RFP Title: Education Center and Pavilion for the Roger Williams Park Zoo

Addendum # 1

New Education Center & Events Pavilion
at the Roger Williams Park Zoo
1000 Elmwood Ave., Providence, RI 02905

September 6, 2023

DEMOLITION PLAN

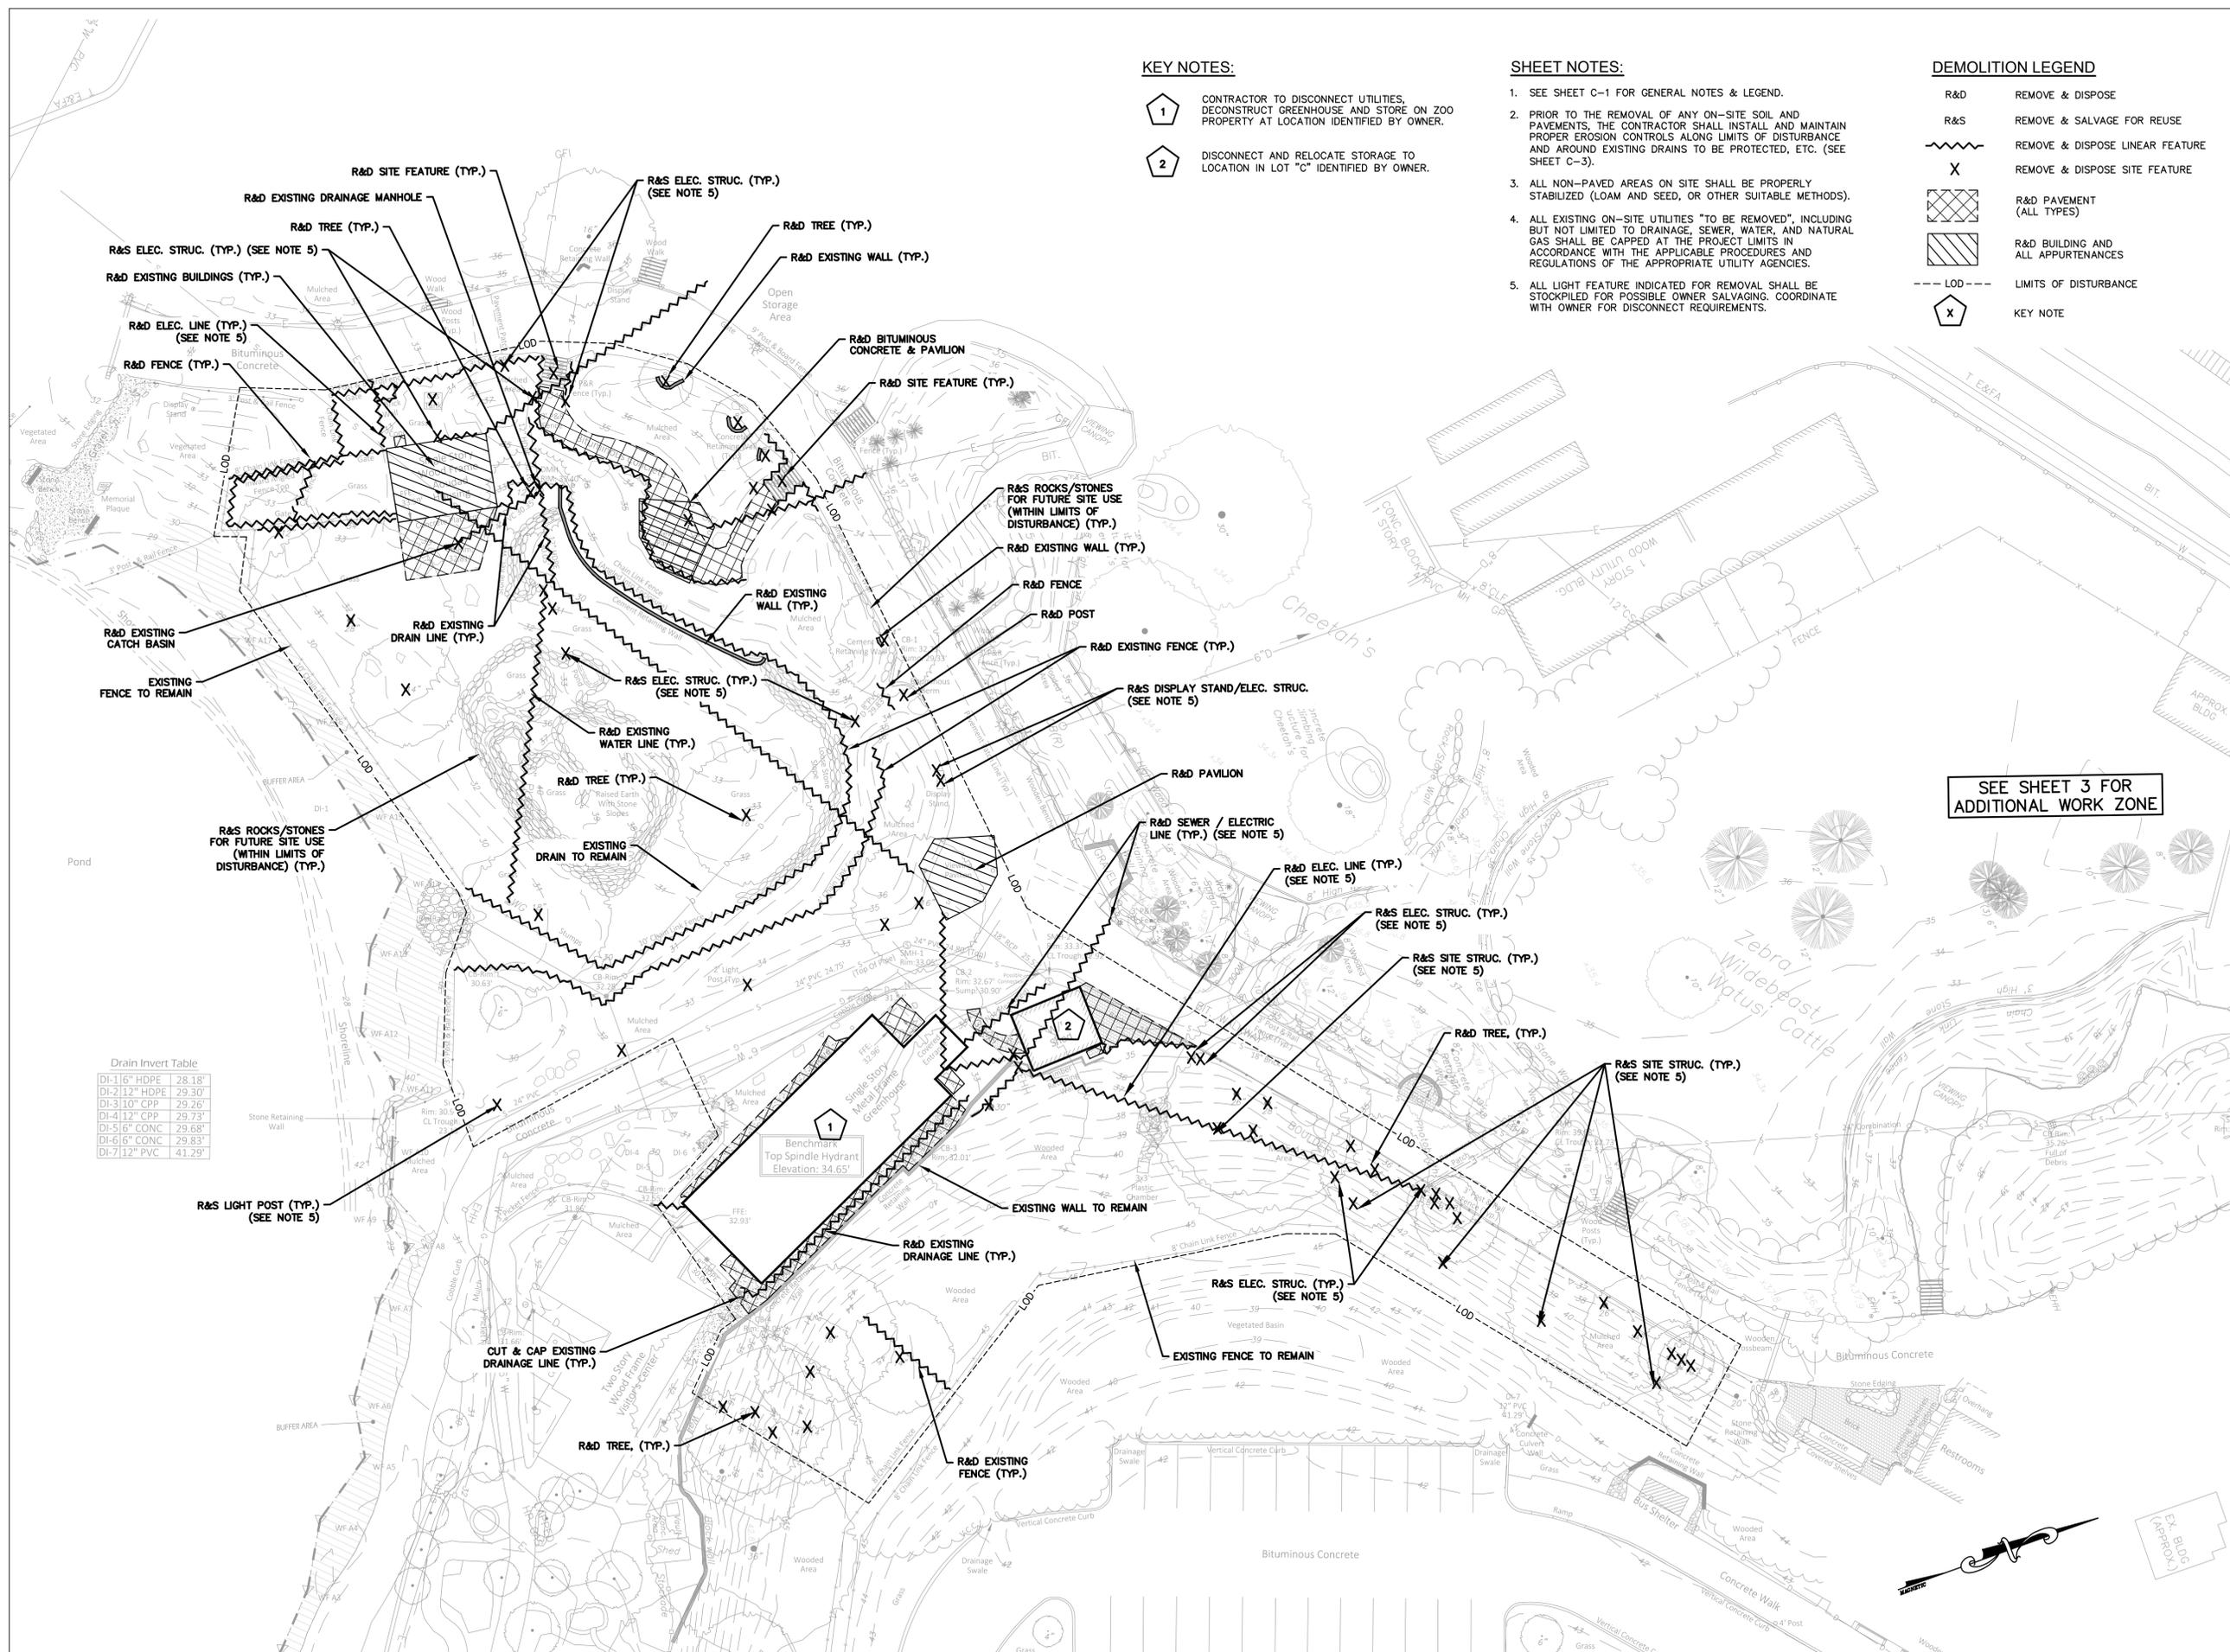
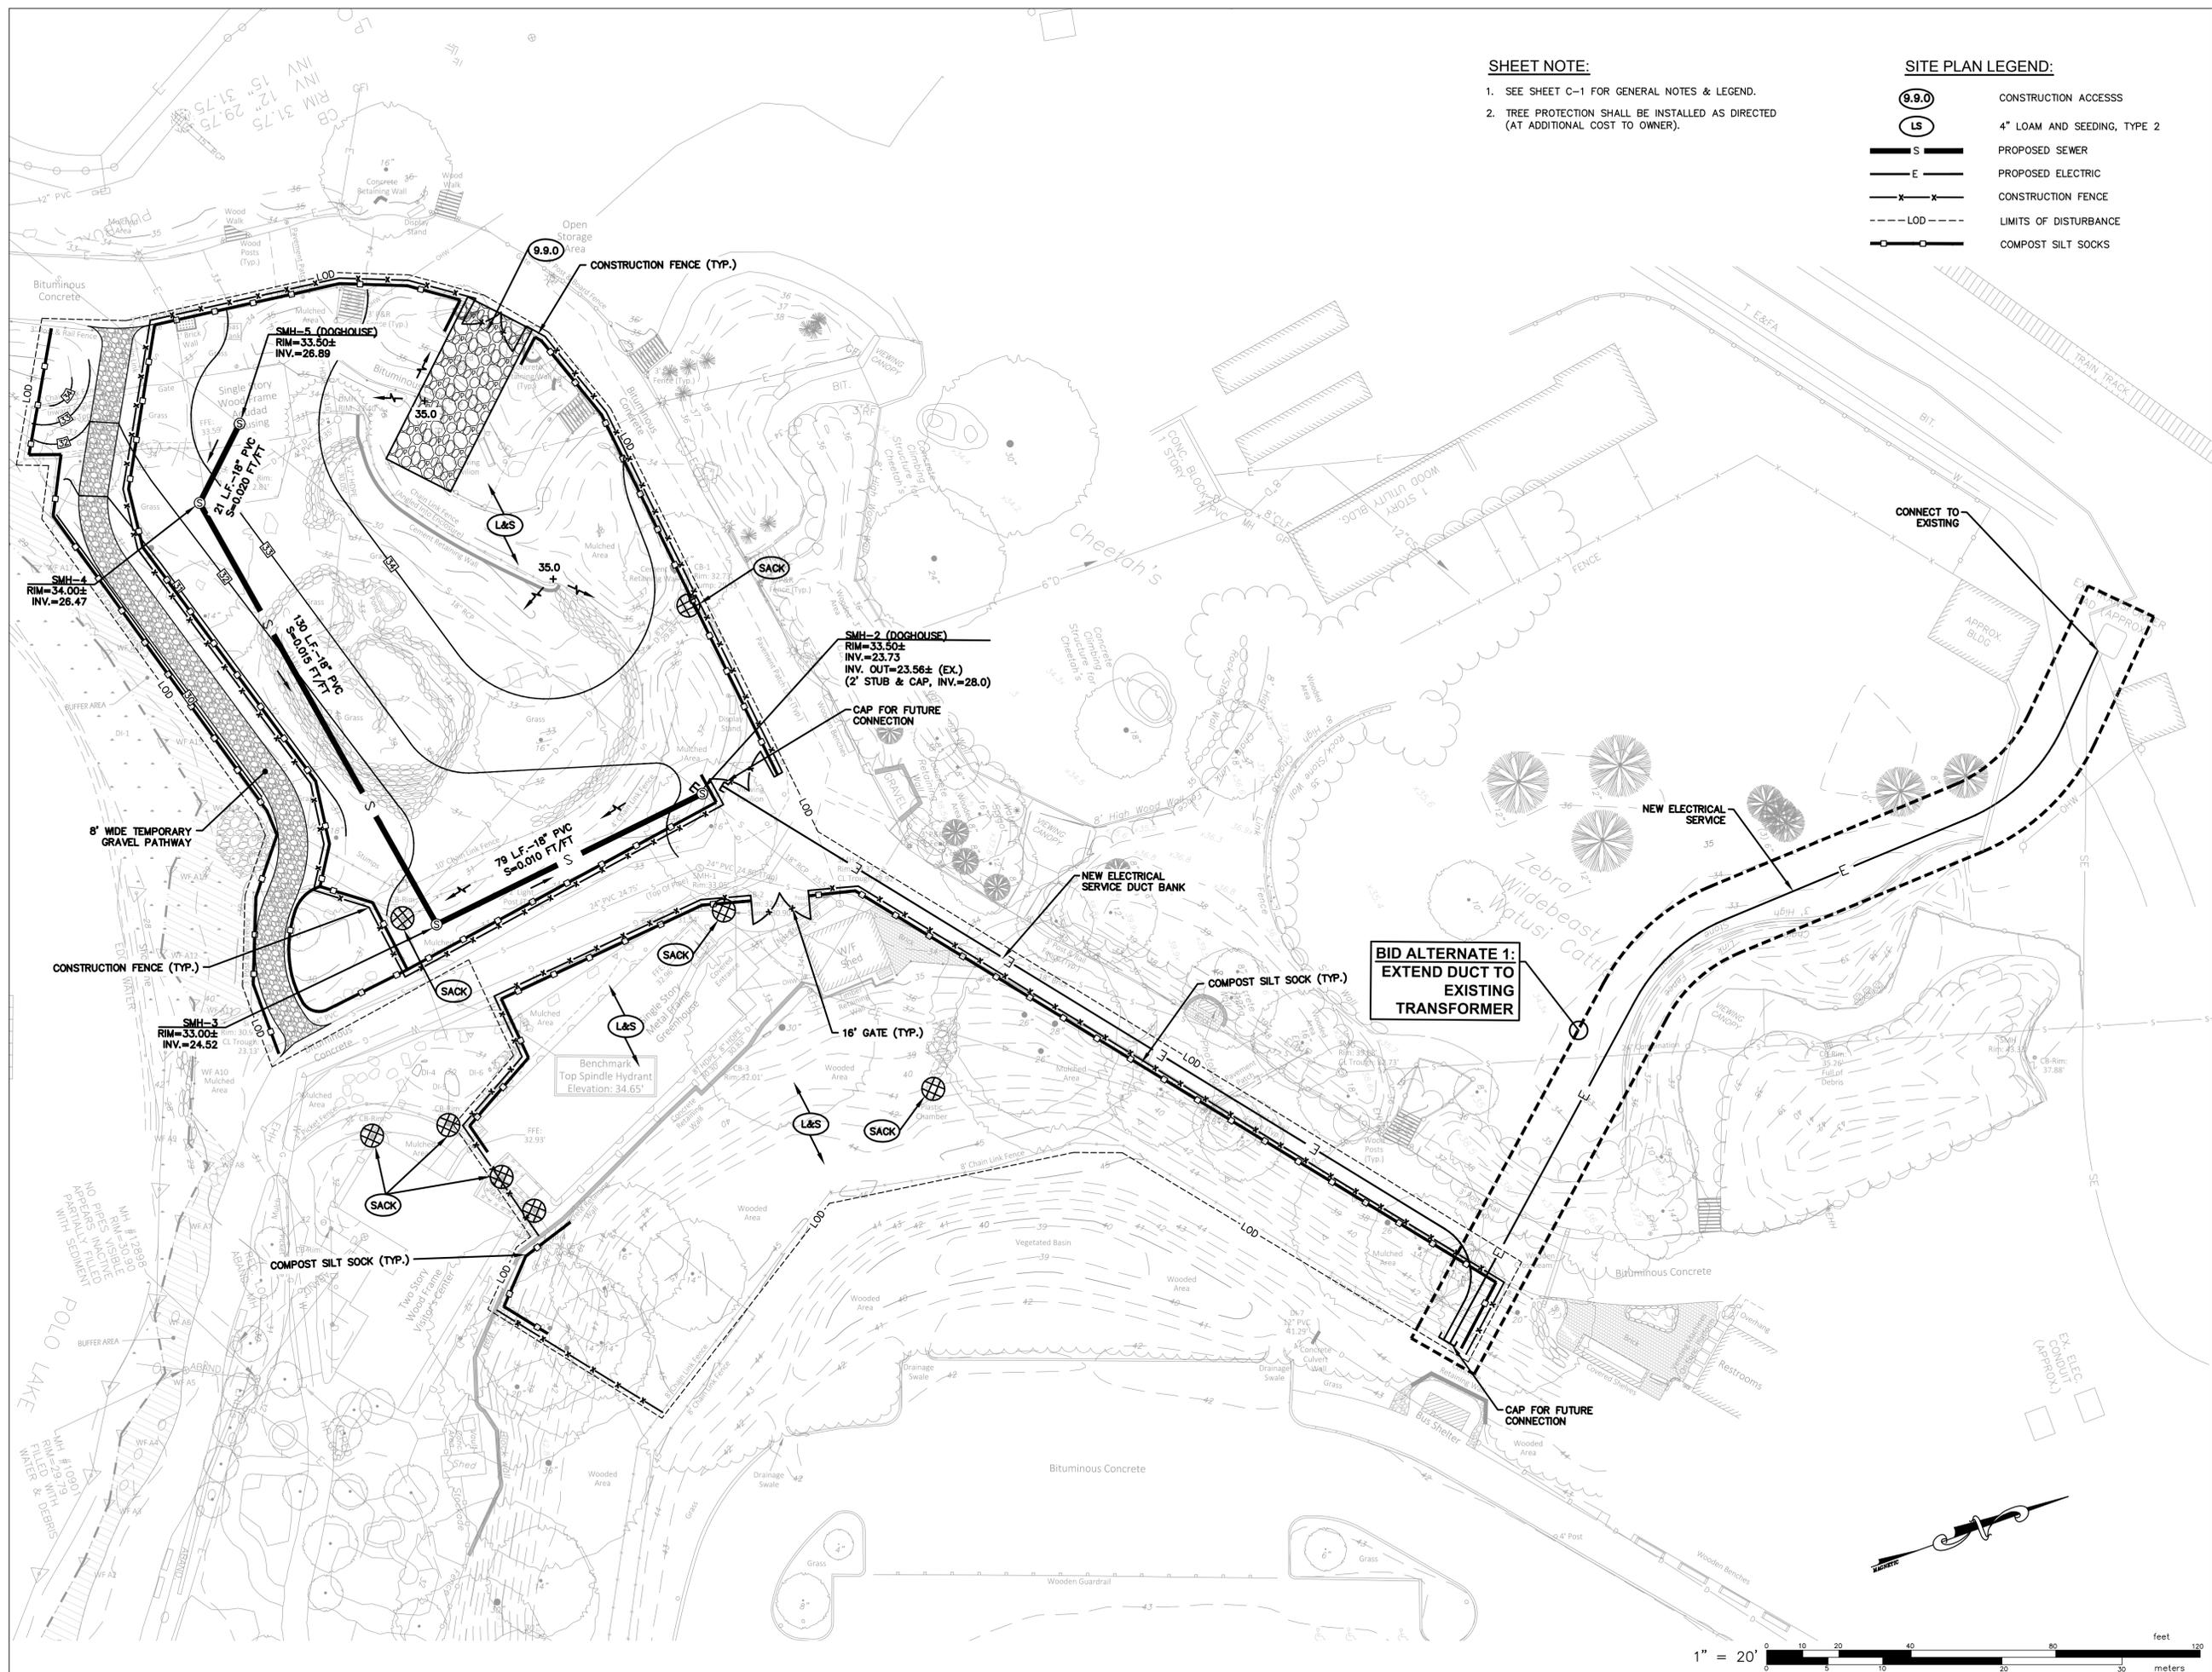
5. Question: Demolition Note #3 on C-3.0 indicates that the Greenhouse and Shed will be relocated by the Owner under a separate contract. Please confirm what scope of work the Contractor will be required to perform.

Response: The Greenhouse and Shed noted to be relocated by the Owner are to be relocated by the GC. The Shed is to be relocated to Parking Lot C, adjacent to the proposed Horticultural Compound. The Greenhouse is to be disassembled and transported to the same location as the Shed. The Greenhouse is to be disassembled in a manner that it can be reassembled for future use. The GC is responsible for demolishing all foundations, concrete slabs, remaining walls, and all utilities from the sites of the Shed and Greenhouse.

DUCT BANK
NOT TO SCALE

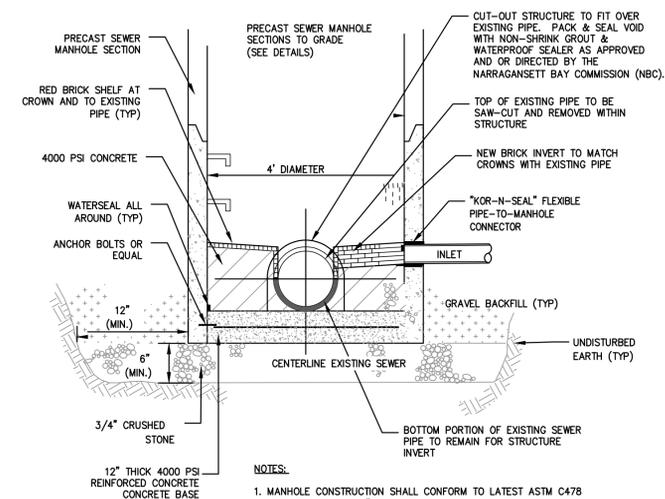
4. Question: On dwg. ES-1.1 it calls for reinforced concrete duct bank – please provide the size, arrangement, and spacing of the rebar.
Response: See attached SKE-1 for duct bank detail.
